**Amendment to Approved Project**

Project name Subdivision for Thomas Aubert, Carole Court, off Portland Street

Description of amendment Revise the rain garden designs on site to be congruent with current design methods

Re: Rain Garden Revisions  
Carole Court & Portland Street

RAIN GARDEN #4 CONSTRUCTION REVISION

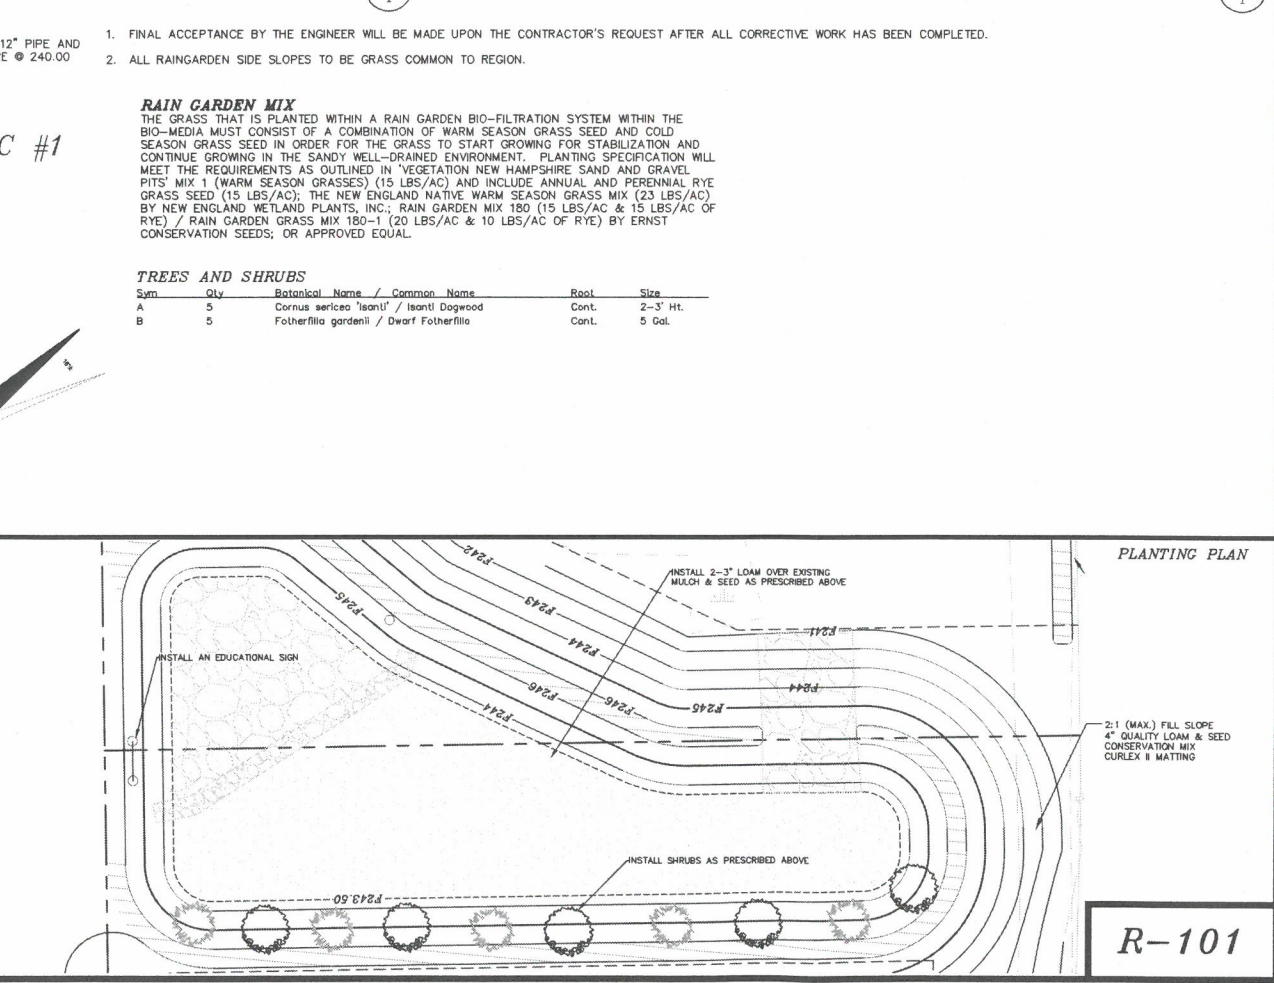
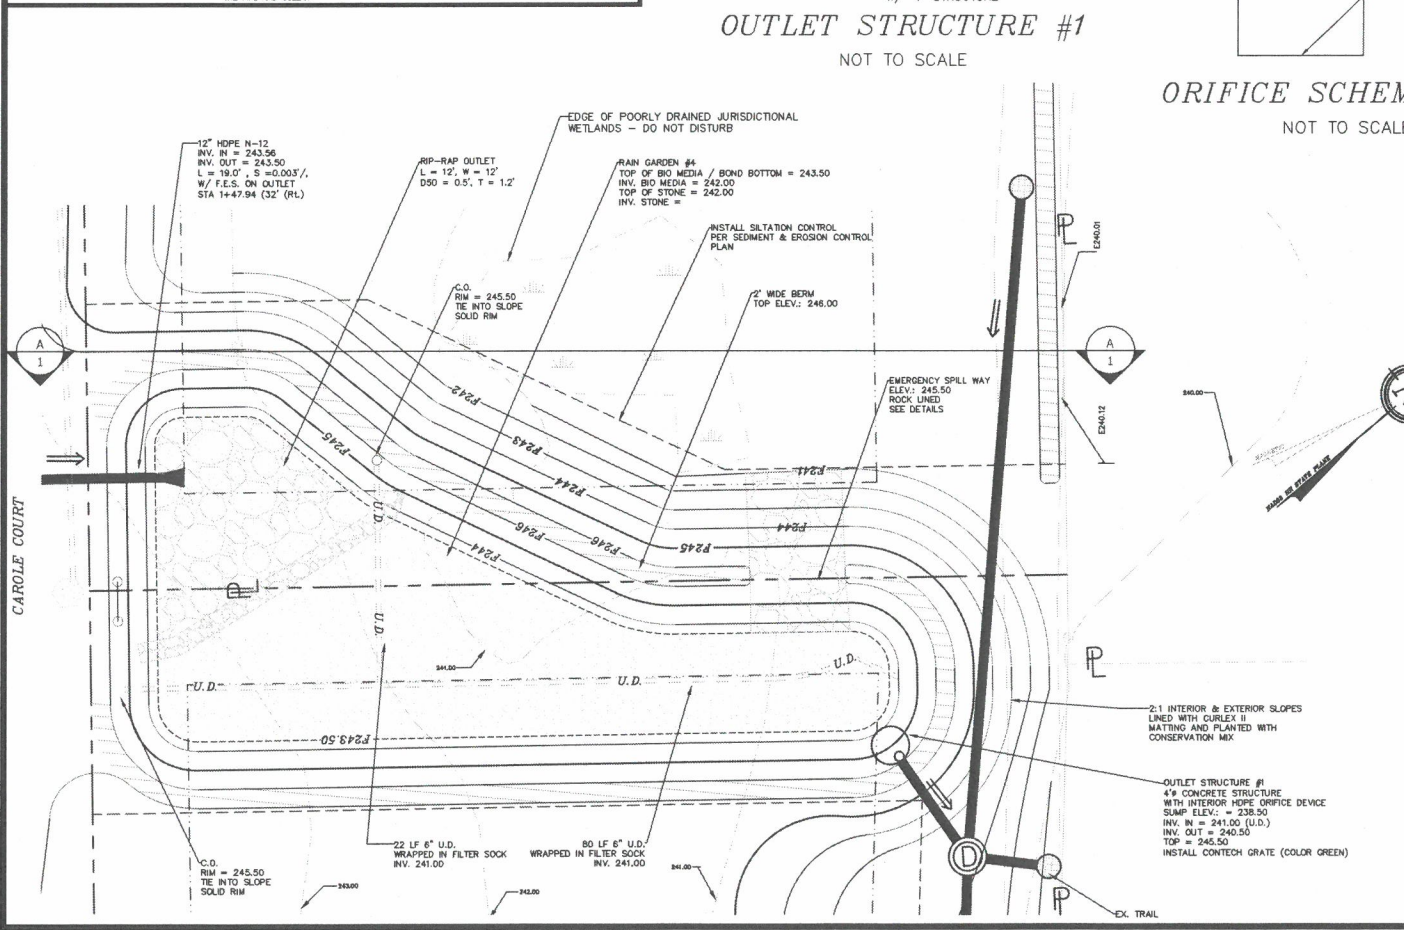
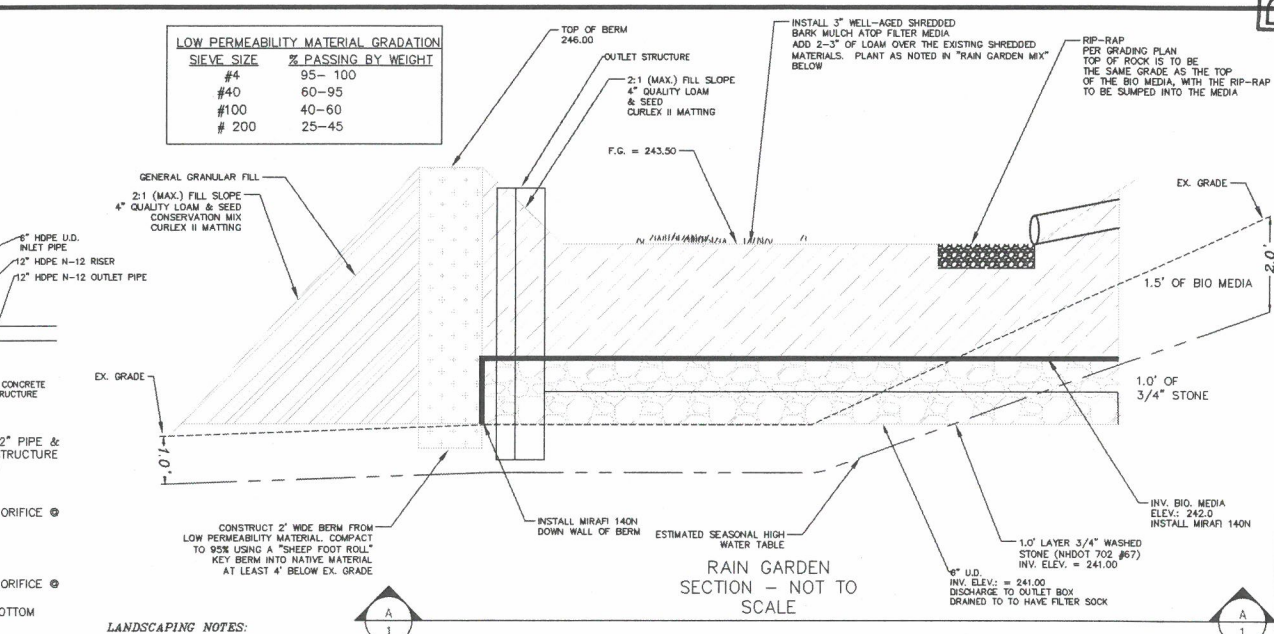
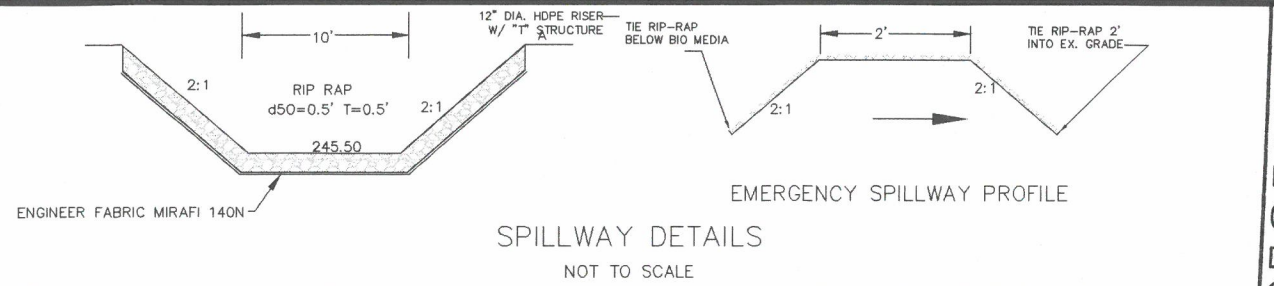
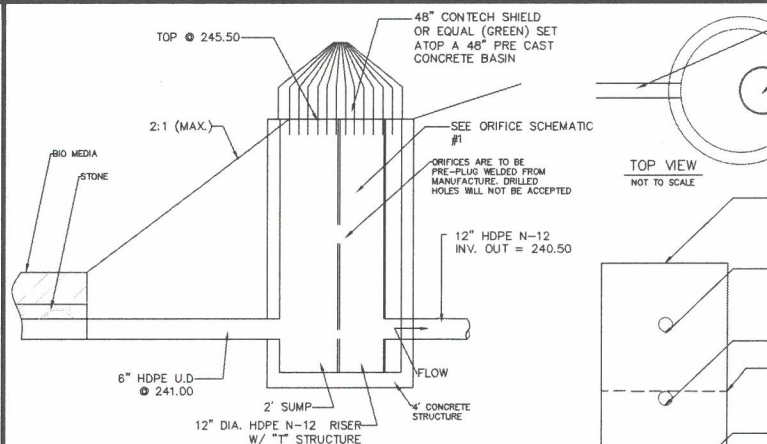
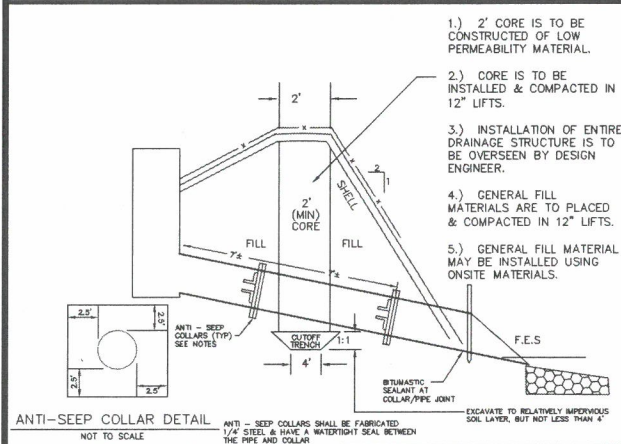
**Rain Garden #4:**

Rain Garden #4 is built per the design plan with the exception of the top dressing and plantings prescribed. The revision request for this system is as follows per our last meeting:

- Top dress the existing mulch with 4" loam and seed per the enclosed design plans. This includes removal of larger shredded materials over 1.5" in size.
- Install 10 bush style plants along the southern slope to clearly define the transition between private lawn area and rain garden area, as a physical deterrent.
- Install a larger, two posted, sign, with an education statement about the rain garden per your request.

RAIN GARDEN #1 & #2 CONSTRUCTION REVISION  
 FOR  
 TOM AUBERT  
 788 AND 794 PORTLAND STREET  
 ROCHESTER, NH  
**TAX MAP 107, LOT 54 AND TAX MAP 108, LOT 53-1**

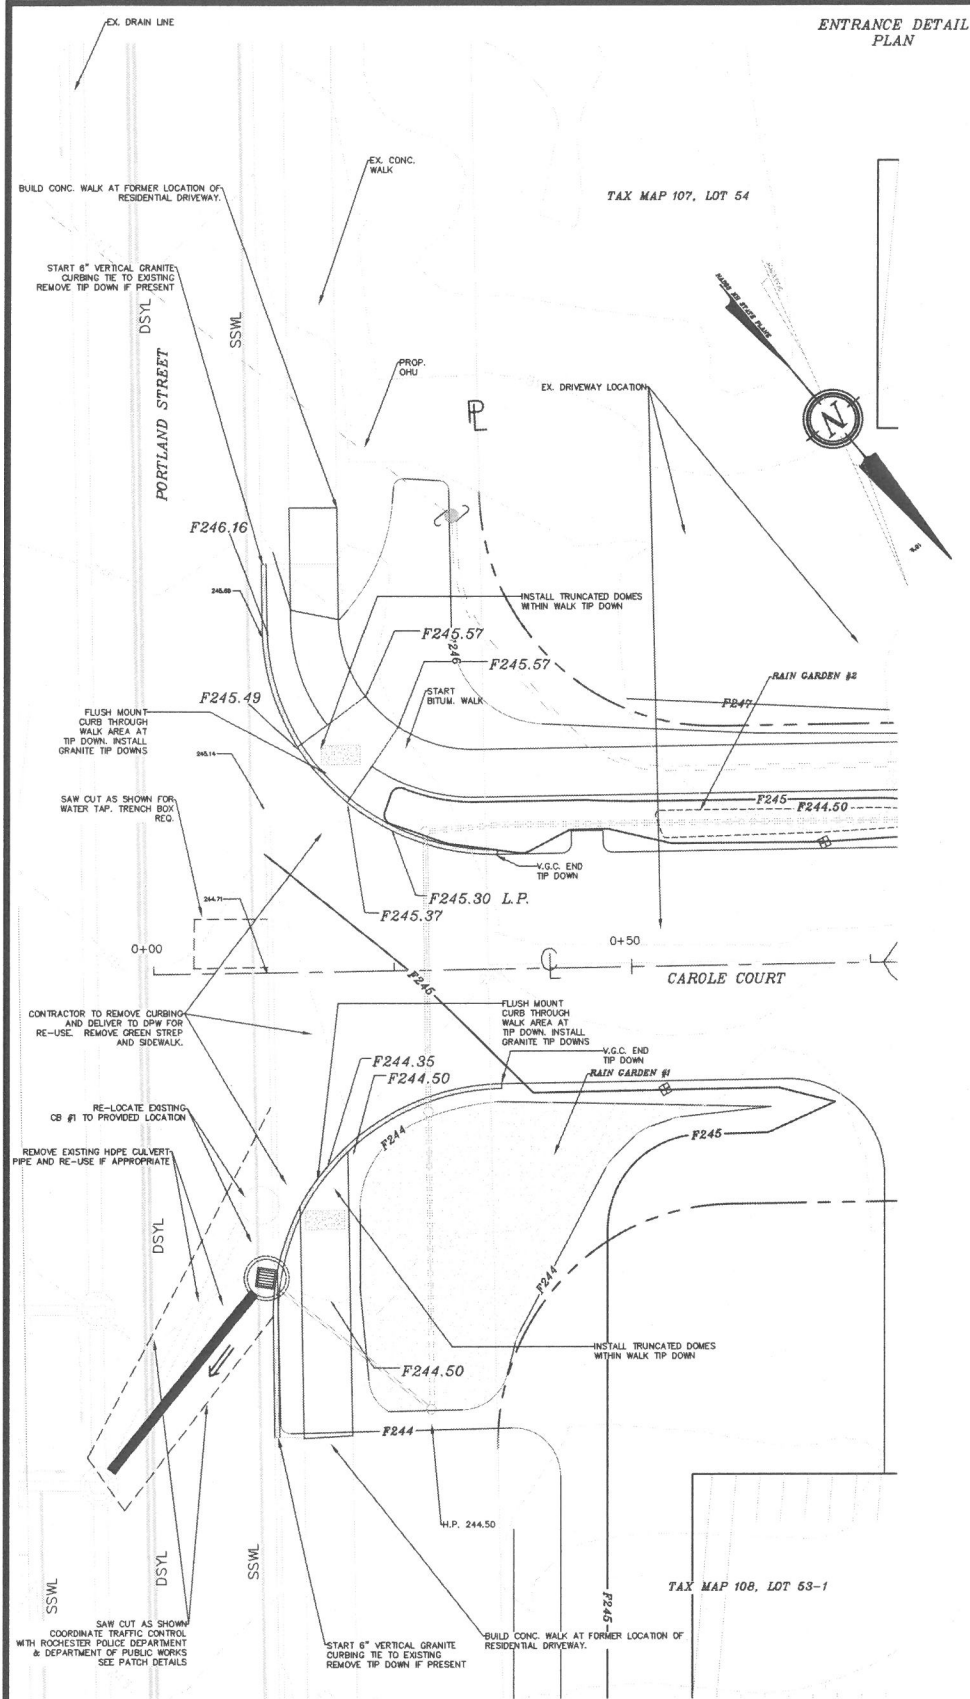
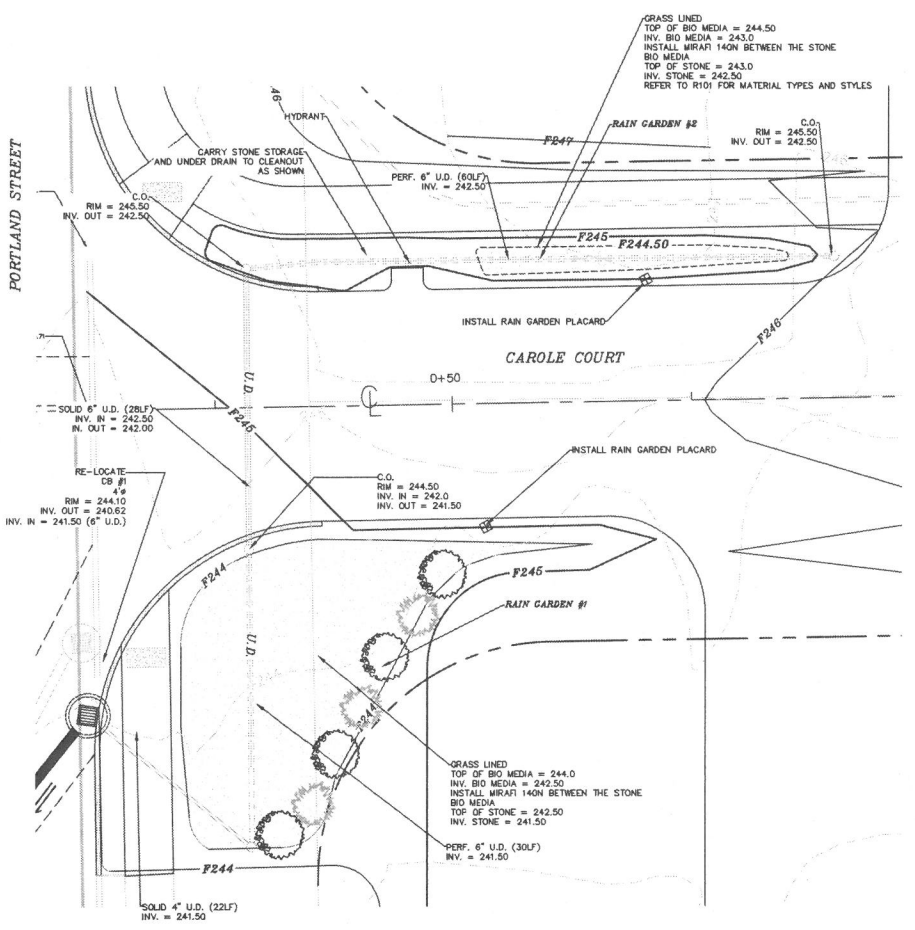
### **Rain Garden #1:**

Rain Garden #1 is now proposed to be a grassed lined ponding area for the lower section of Carole Court and has recently been revised to remove the silt and additional loam placed during construction. The revision request is to plant the bio-

media with grass as prescribed on the revised plan and has been done on site during the fall of 2019. The plants have largely been removed however we have left 7 of the original shrubs. The idea is to keep a break between what is municipal road / rain garden and private lawn and was preferred by you and DPW during our last meeting. The shrubs were discussed with the current home / lot owner and that is the preferred choice. As suggested, we have added a plaque sign, similar to a buffer sign, to the plans to make people aware that it is a bio-retention system. This will be installed during the spring of 2020.

**Rain Garden #2:**

Rain Garden #2 is a swale between Carole Court and the sidewalk. This swale was an effort to provide first flush treatment to the MS4 and the discharge point to the MS4. This swale was re-constructed during the fall of 2019 to provide the ponding area it was formerly lacking. The area has been re-loamed and seeded, and has been planted per the seeding specifications on the plans. The shrubs formerly provided on the original design have been removed as suggested in our last meeting to decrease maintenance in the future and reduce crowding in this area. As suggested, we have added a plaque sign to the plans. This will be installed during the spring of 2020.
